LAKE PONTCHARTRAIN, LA.
AND VICINITY
LAKE PONTCHARTRAIN
HIGH LEVEL PLAN

DESIGN MEMORANDUM NO. 17
GENERAL DESIGN

**JEFFERSON PARISH
LAKEFRONT LEVEE**

Lake Pontchartrain, La & Vic/High Level Plan
GDM No. 17A - Jefferson/St. Charles Return Levee-
2nd End.

JEFFERSON / ST. CHARLES PARISH
RETURN LEVEE
REACH I - NET LEVEE EL 5.0
B/L STA 74+00 TO STA 140+00
(NON-CONT)

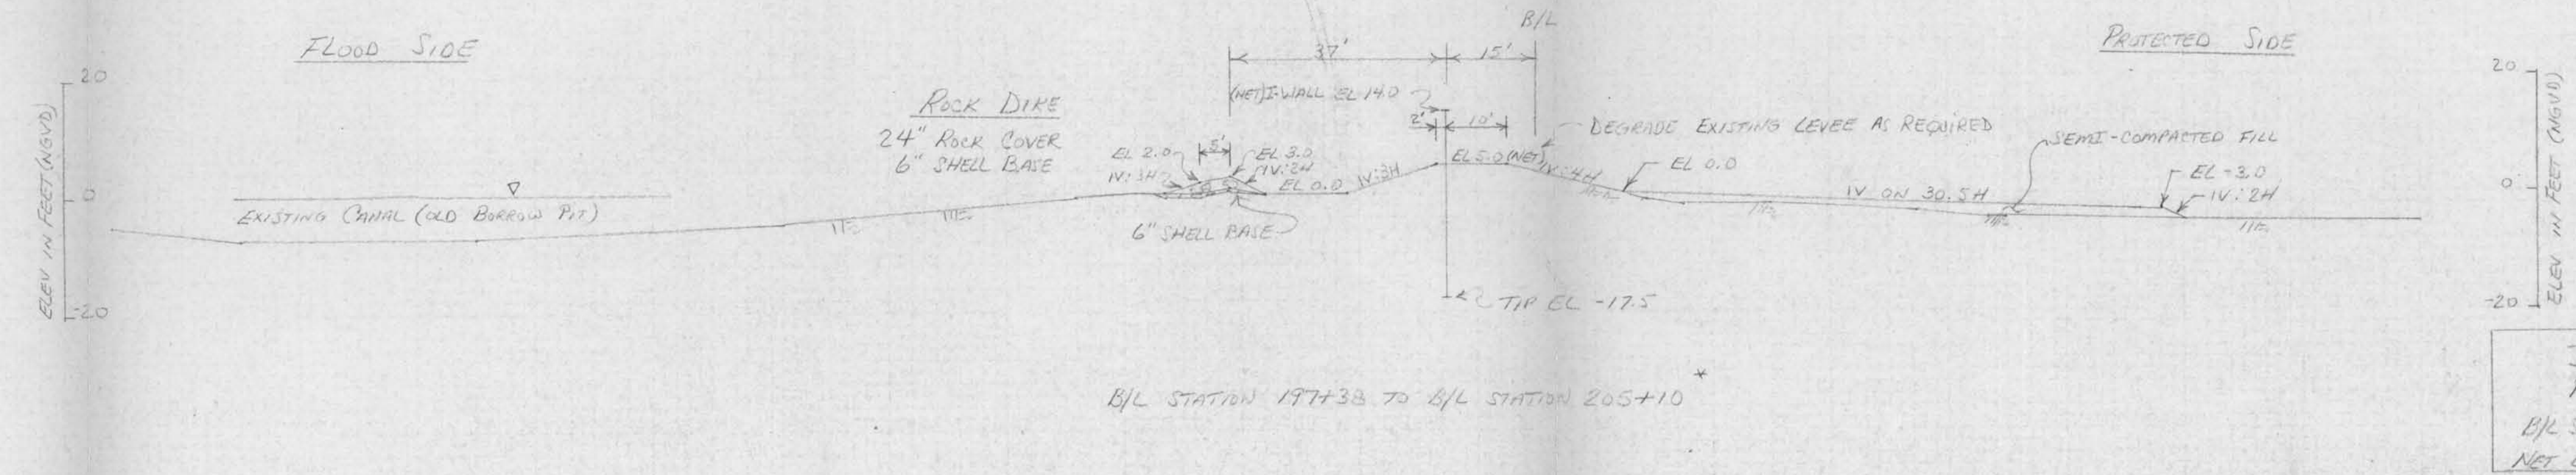
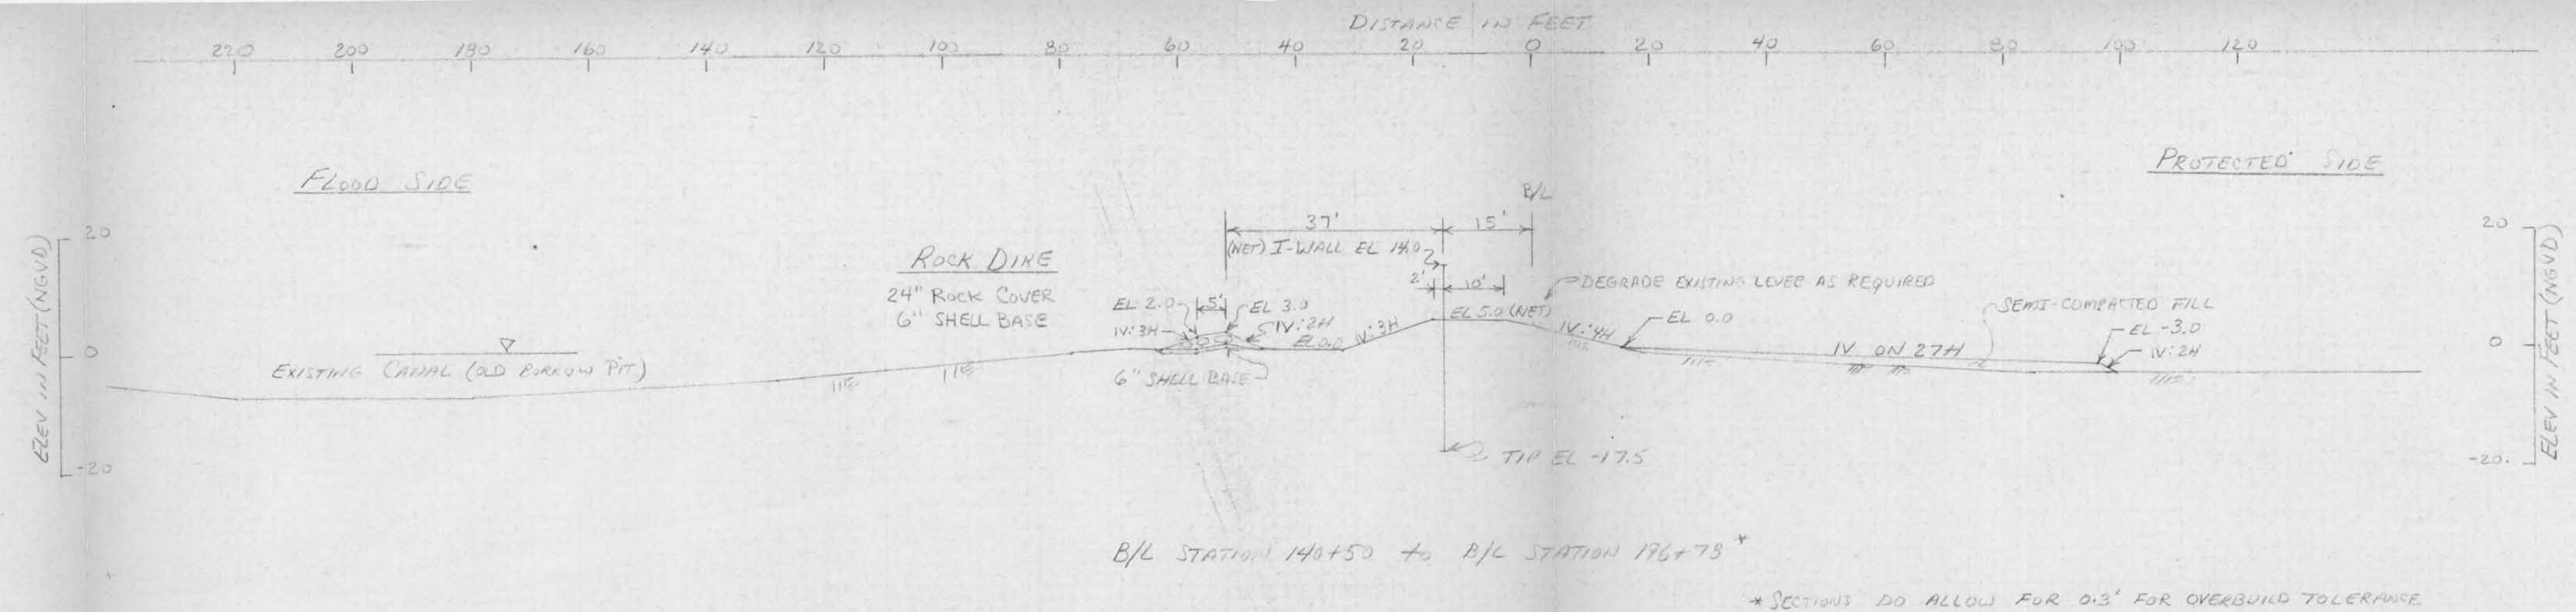
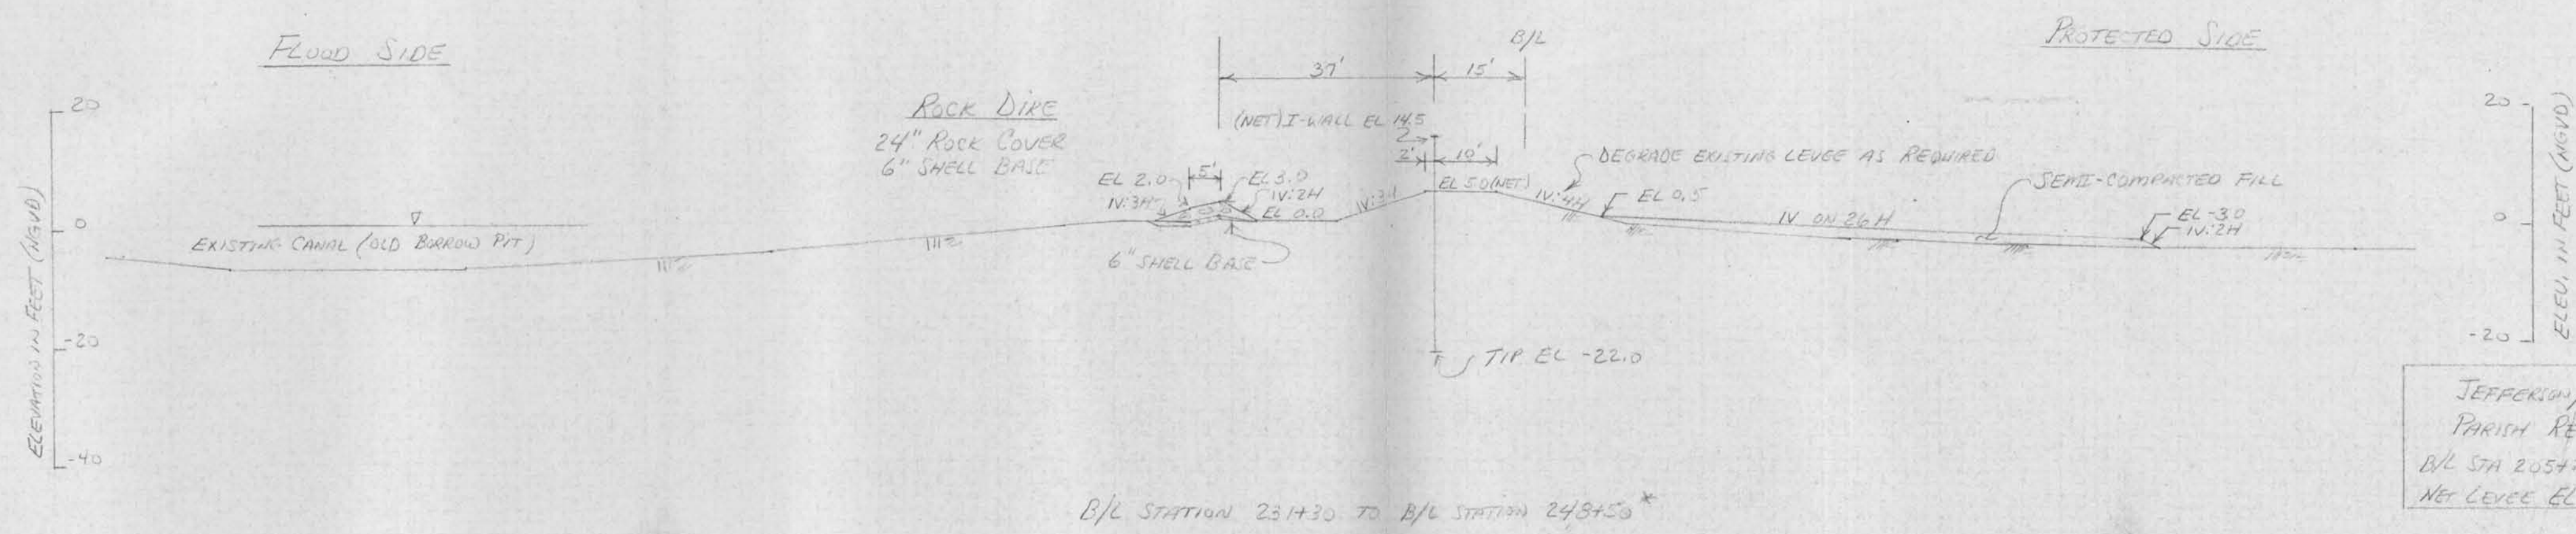
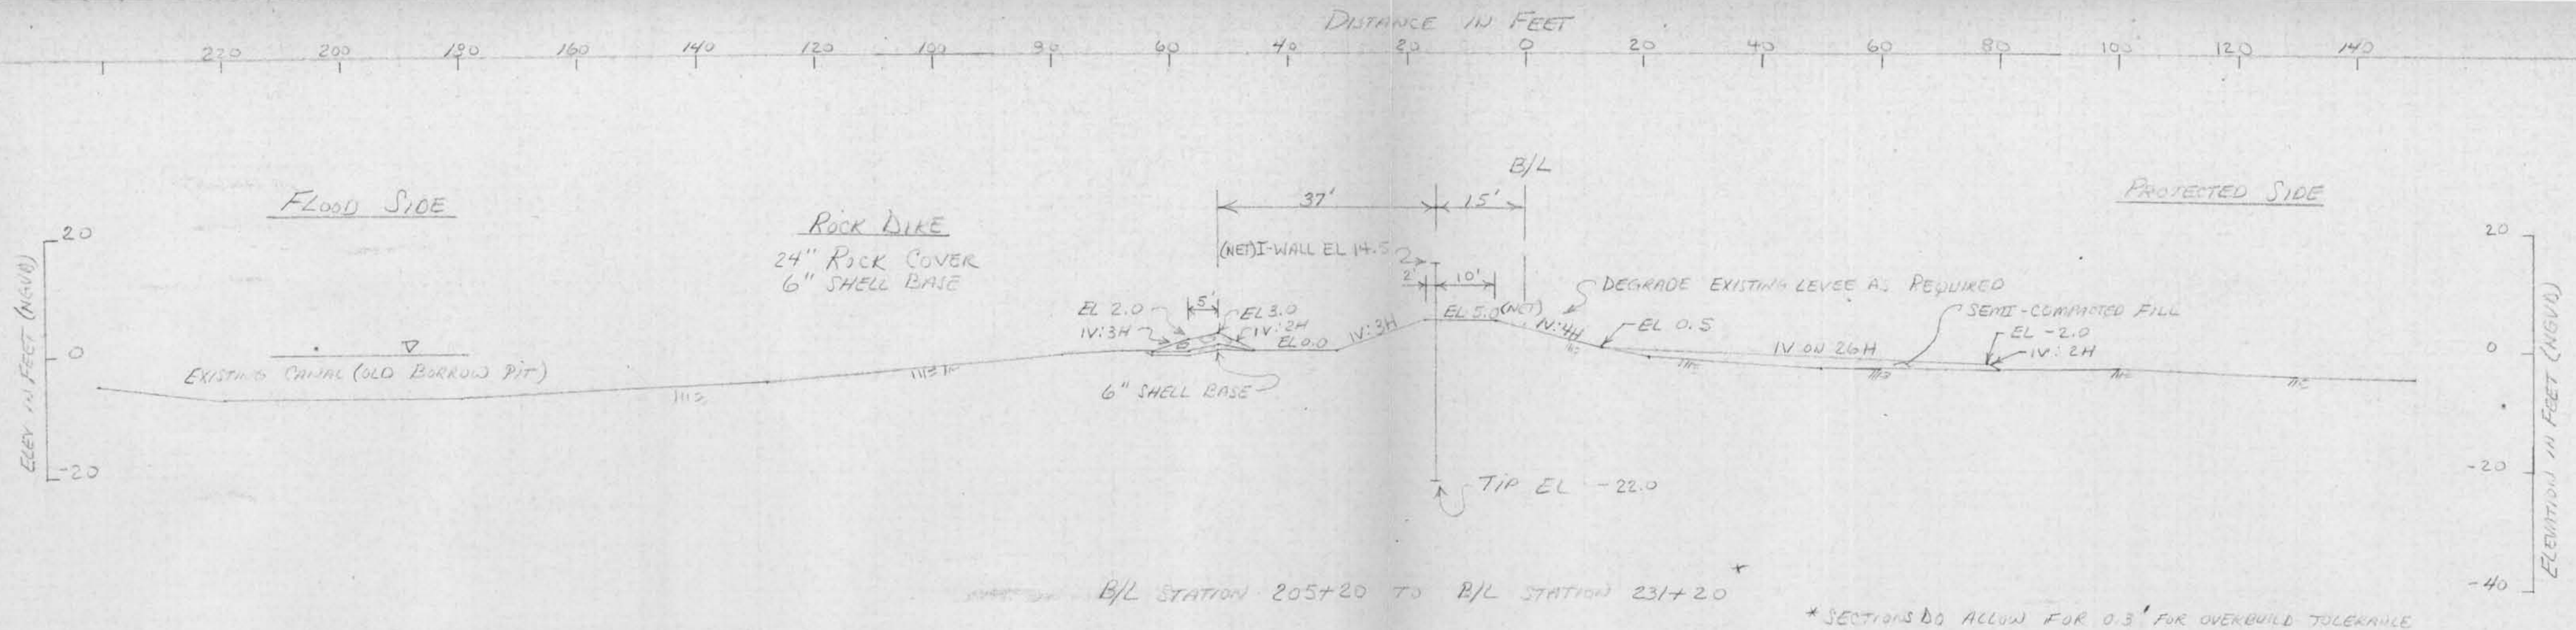
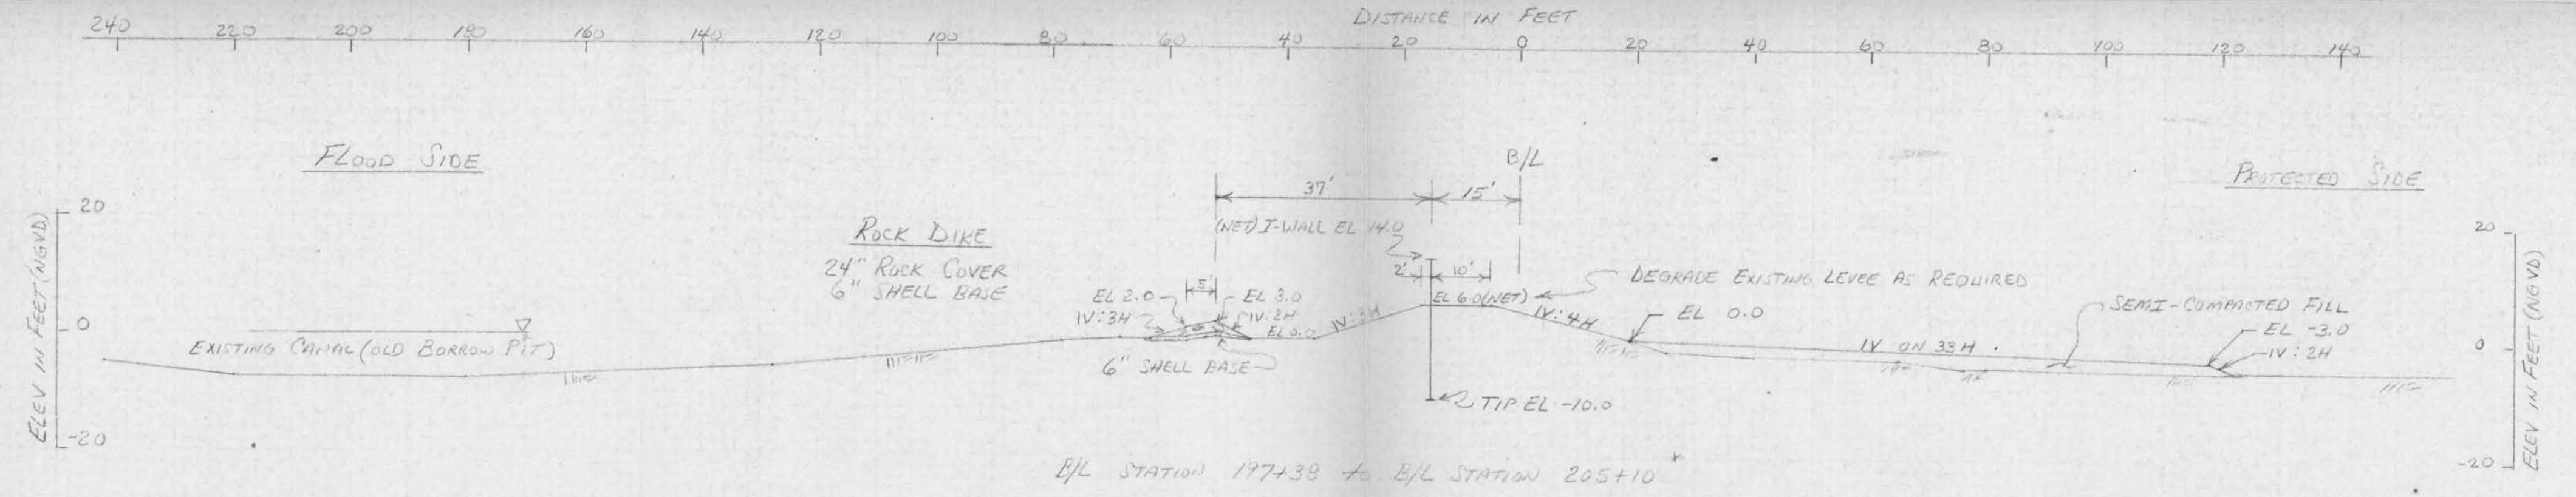
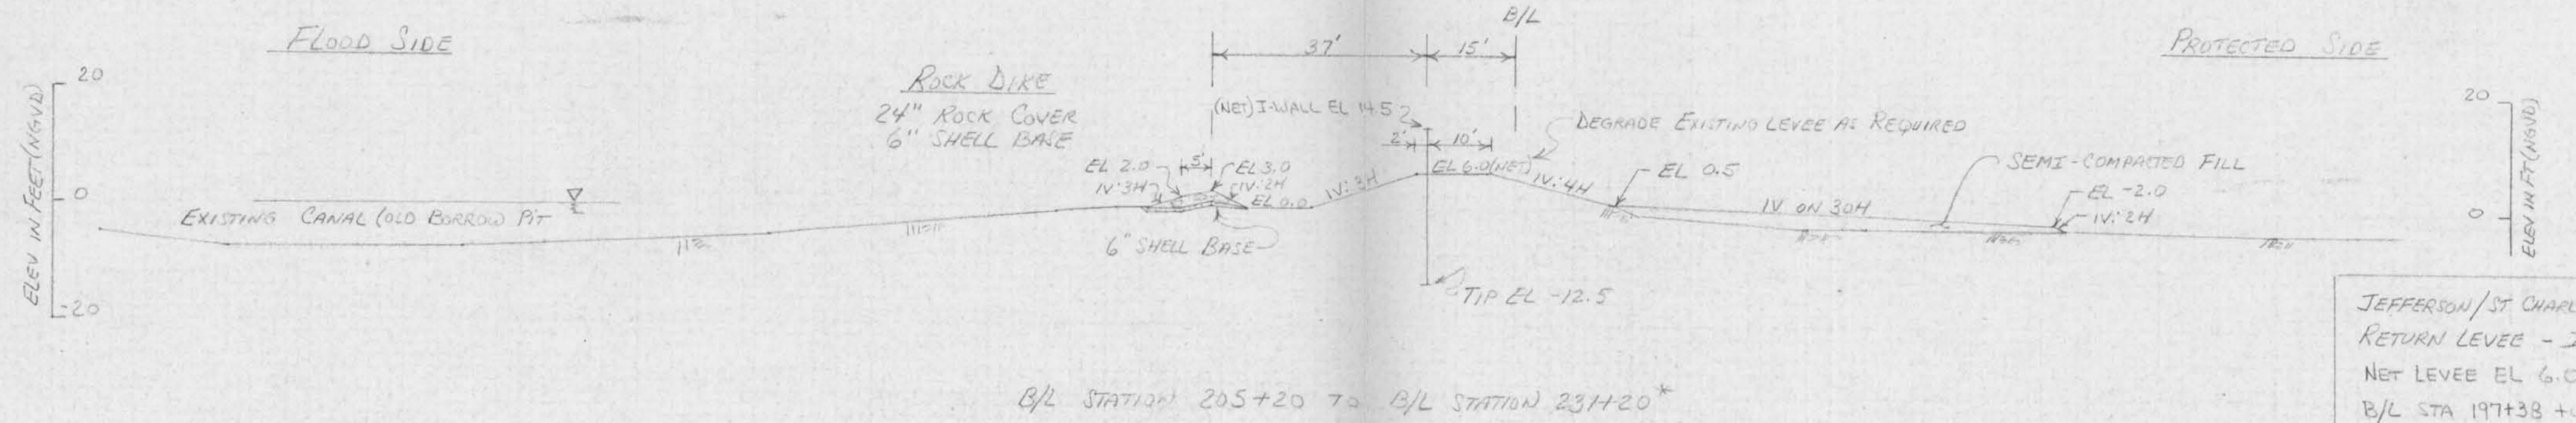
d. Plates 18 and 19. The proposed I-wall alternative design shown on these plates consists of degrading the existing levee, filling the adjacent canal with uncompacted fill, relocating the canal, and constructing a levee/I-wall on the uncompacted fill. This alternative is obviously prohibitively expensive, and in addition, construction would be difficult. The most desirable and economical I-wall design would be to degrade the existing levee to the maximum extent possible, construct an I-wall near the existing sheetpile alignment, and add protected side stability berms as necessary. We understand that this design alternative was not pursued since protected side rights-of-way constraints precluded berm construction. In order to determine the least costly alternative you should perform the structural and stability analyses for the I-wall constructed on the existing levee crown with a protected side berm. The cost for this alternative, including rights-of-way, should be compared with the proposed T-wall design on a reach by reach basis.

d. Plates 18 and 19. Concur. We have reexamined the I-wall in levee alternative to determine the most cost effective I-wall plan. The minimum degraded levee elevation that could be made to satisfy both foundation and structural stability requirements was determined for the levee reach addressed in this GDM. For the purpose of developing a cost estimate, where existing structures preclude construction of a protected side stability berm, the proposed method of protection would be T-wall construction. In these areas, the costs for acquisition of lands and relocations would obviously be cost prohibitive. In addition to the I-wall alternative with minimum levee height, several other I-wall in levee plans having higher crest elevations were checked to determine if the cost for landside berm and real estate would outweigh any reduction in sheet pile cost. The following tabulation gives a comparison of estimated costs for the most cost-effective I-wall in levee plan along with the corresponding estimated cost for the optimum T-wall, GDM plan.

Based on the forgoing, it is recommended that only the subreach from station 198+00 B/L to station 213+50 B/L be protected by I-wall construction. The comparison of cost for the two types of walls between station 198+00 B/L and station 247+20 B/L shows that both plans would cost approximately the same, with the T-wall being about 2 percent greater in cost than the I-wall in levee with crown elevation of +6 NGVD. We feel that the difference in costs falls well within the allowable error of estimate. The adjacent protected side lands with this reach constitute prime real estate which is slated for medium to high-cost residential development. Many of the properties impacted by the I-wall plan would preclude any construction on the remaining part of the property not taken by the project. Not only would this be an extremely unpopular plan with the land owners but also would adversely affect the future tax base for the Parish and City of Kenner, LA.
